**Re: Response to Agency Letter Dated 3/31/09**  
Former Shell-Branded Service Station  
15275 Washington Avenue  
San Leandro, California

**Subject: Response to Agency Letter Dated 3/31/09**  
Former Shell-Branded Service Station  
15275 Washington Avenue  
San Leandro, California

On behalf of Shell Oil Products US (Shell), Delta Consultants, Inc. (Delta) has prepared this response to your letter referenced above regarding the Soil Vapor Extraction Test Work Plan and Groundwater Sampling Work Plan, both dated January 27, 2009, for the site referenced above (Figure 1).

FIGURE 2

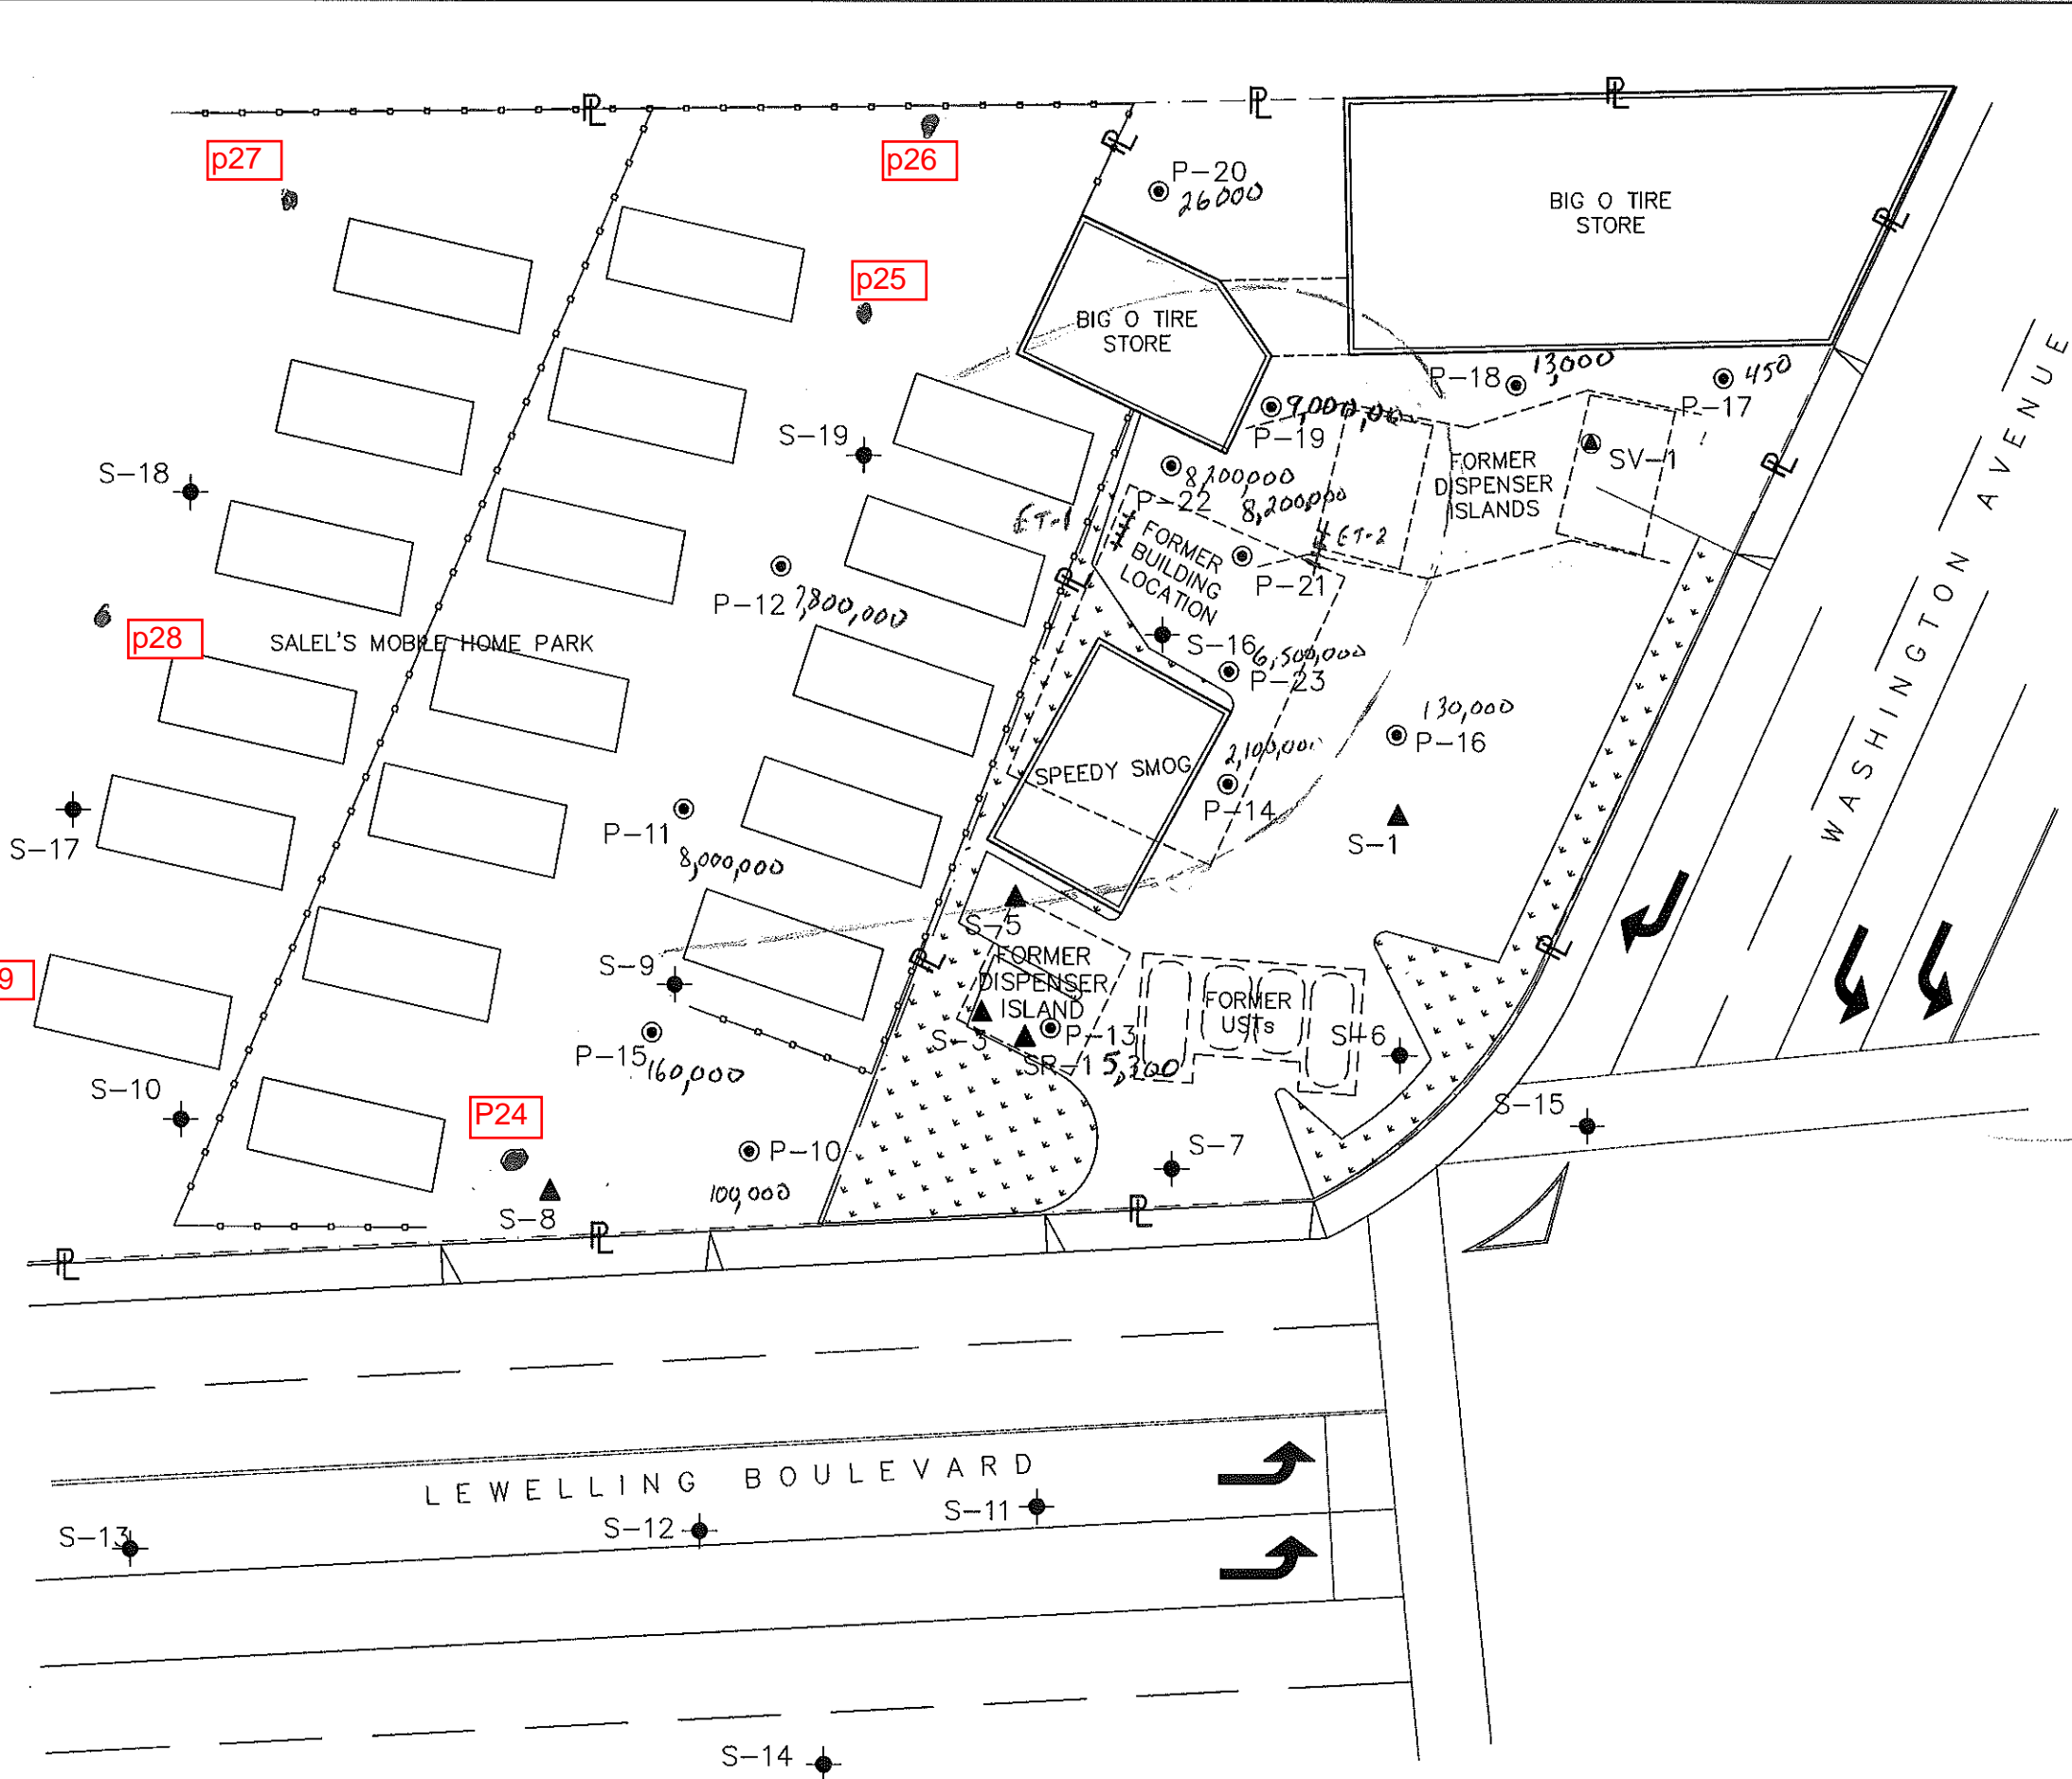
At a meeting with you on March 12, 2009, you requested that we review the soil vapor survey for completeness and recommend additional sampling points as necessary.

Based on the results of the soil vapor survey conducted in June 2008, it is apparent the down-gradient extent of vapor intrusion has not been determined. As shown on Figure 2, we propose an additional 6 soil vapor survey sample points. A work plan will be submitted within 30 days proposing additional vapor sampling points.

Technical Comment 4 will be addressed under separate cover; a work plan for additional soil vapor survey sampling will be submitted within 30 days. A site map has been included showing the proposed location of nine additional soil vapor survey sampling points (Figure 2).

**FIGURE 5**

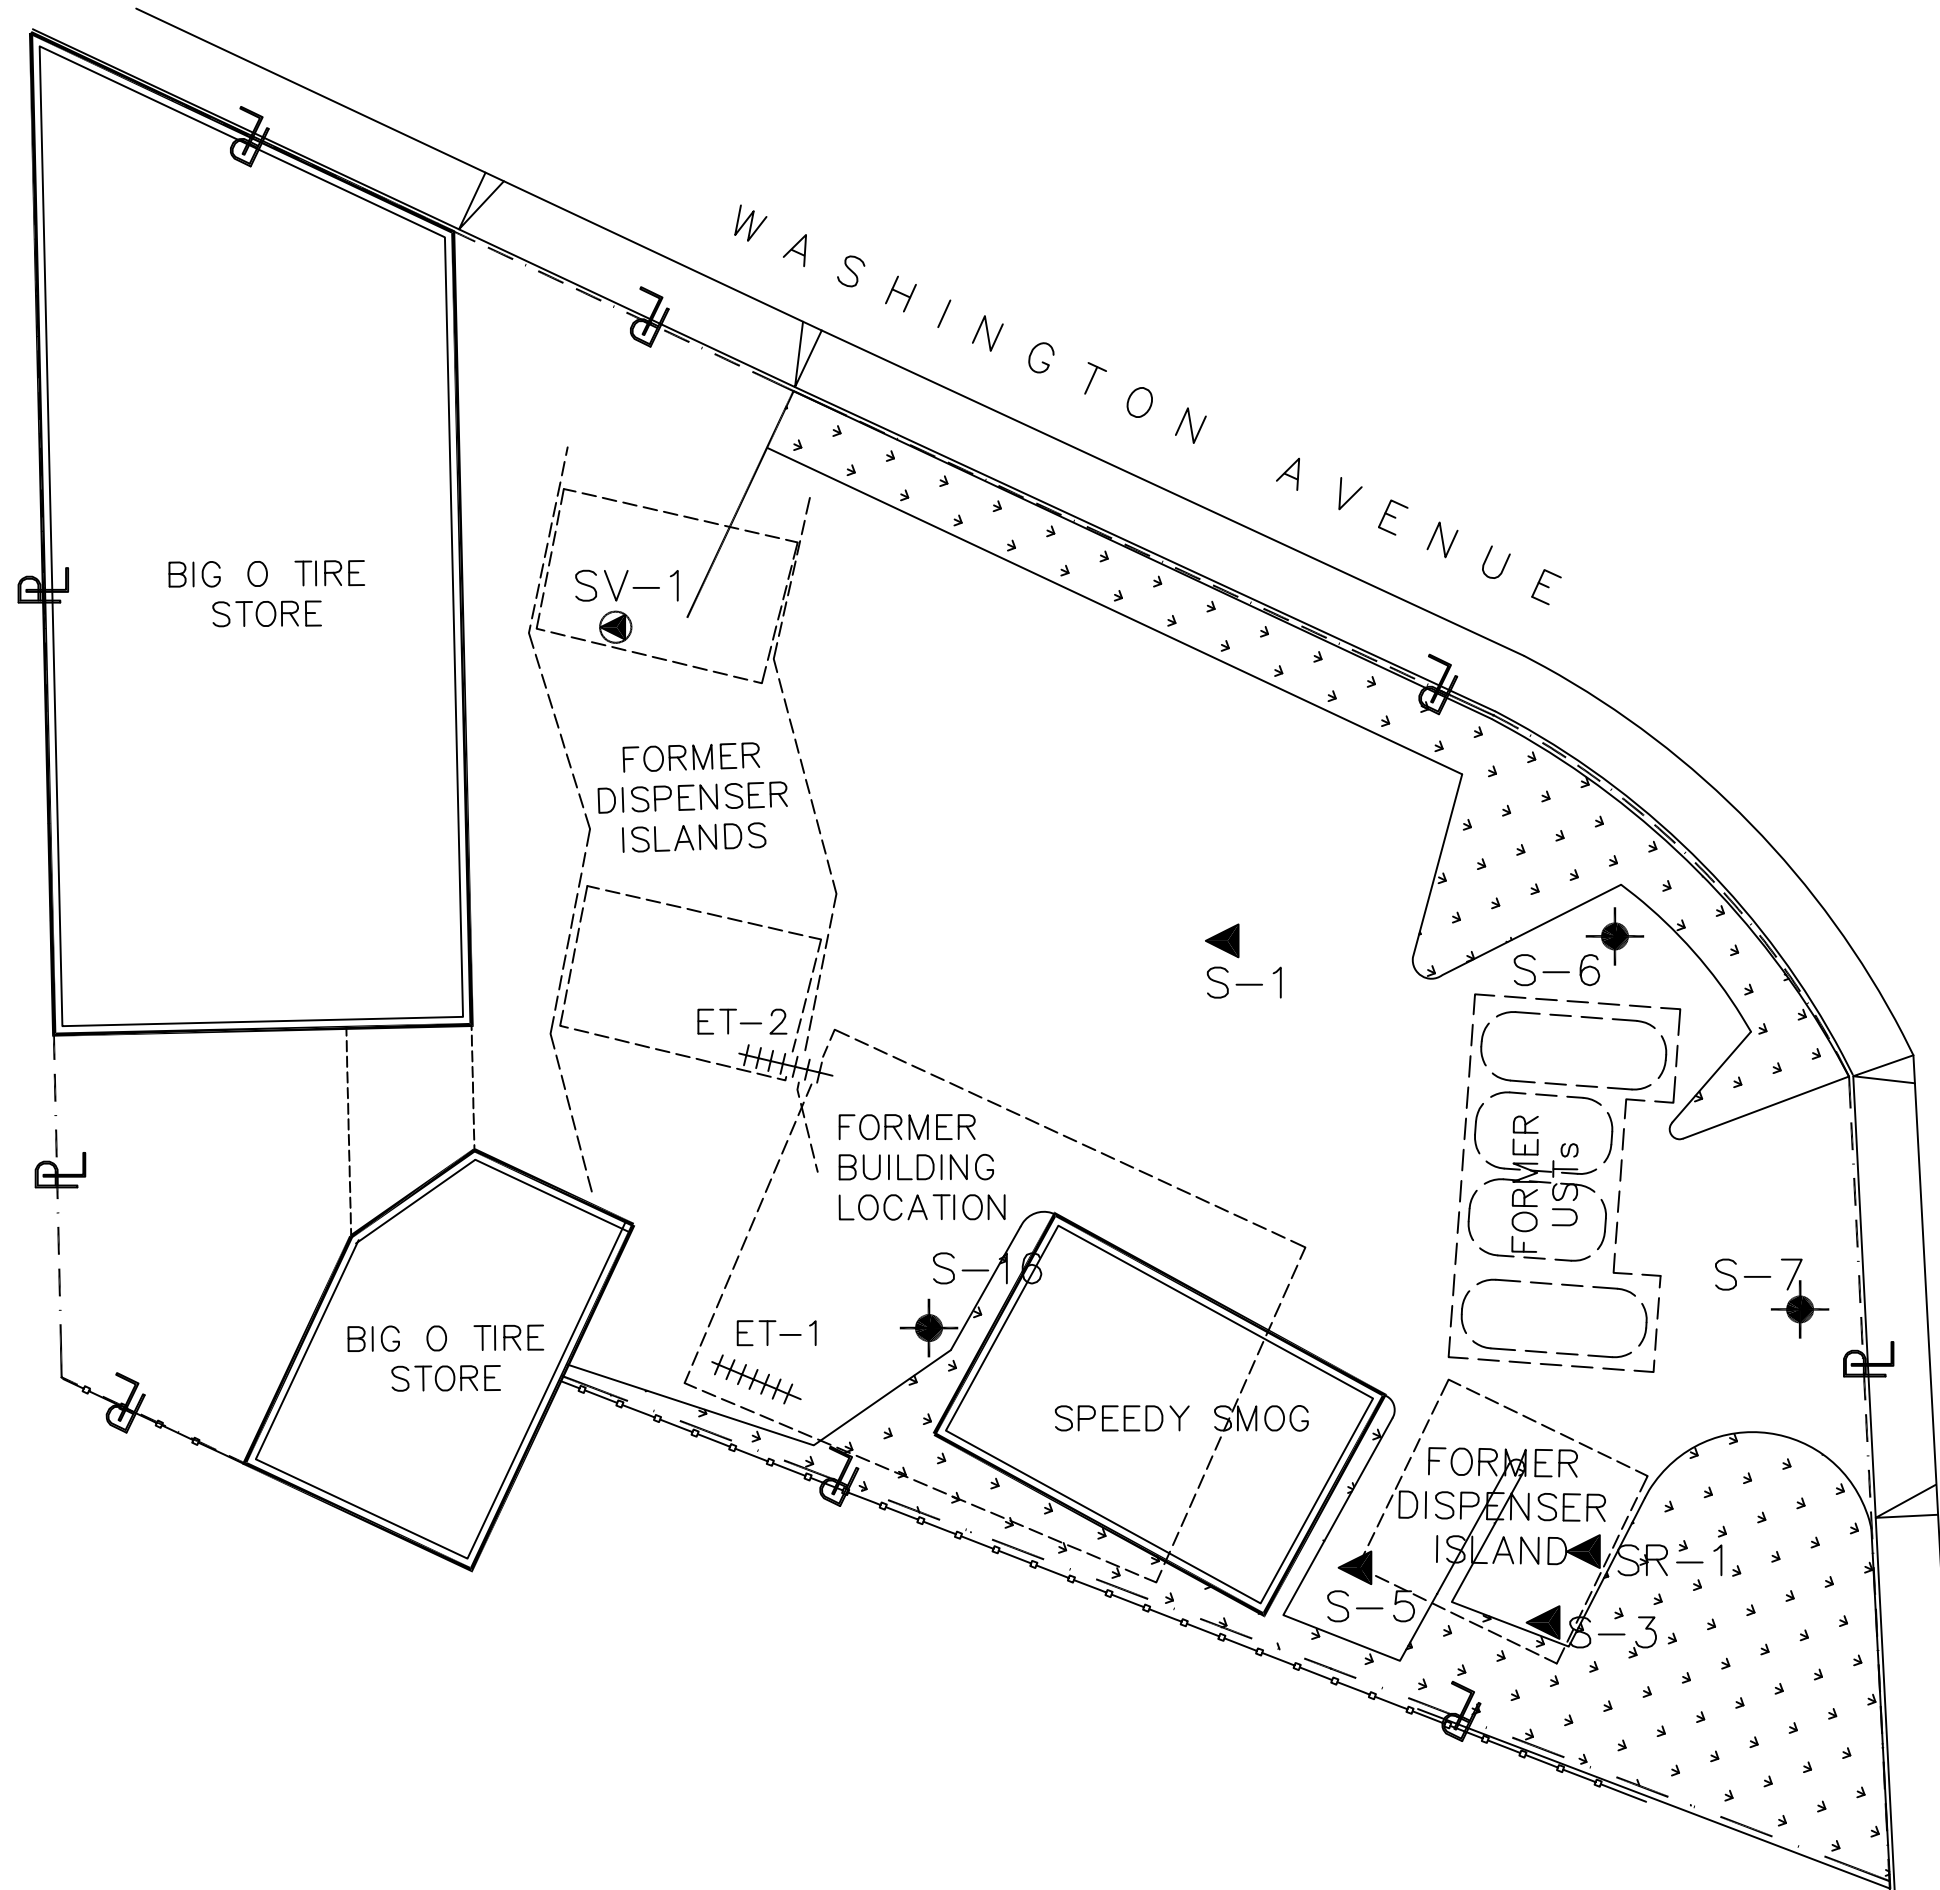
Concern was expressed over the suspected presence of a former soil vapor treatment system trenches near extraction trench ET-2.

As shown in the attached revised Figure 5 included as Attachment A, Extraction Trenches ET-1 and ET-2 have been relocated to the north of the existing building, away from the suspected former SVE piping trenches and still near the center of the impacted area.
